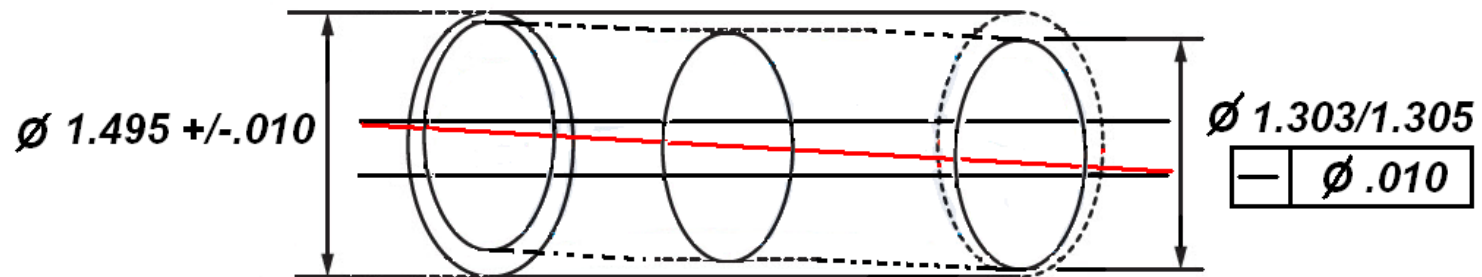
**Straightness is only called out for the inner Diameter.**

**Wall thickness can be as thin as .085 ((1.485 - 1.315)/2) or**

**As thick as .106 ((1.505 - 1.293)/2) ?**
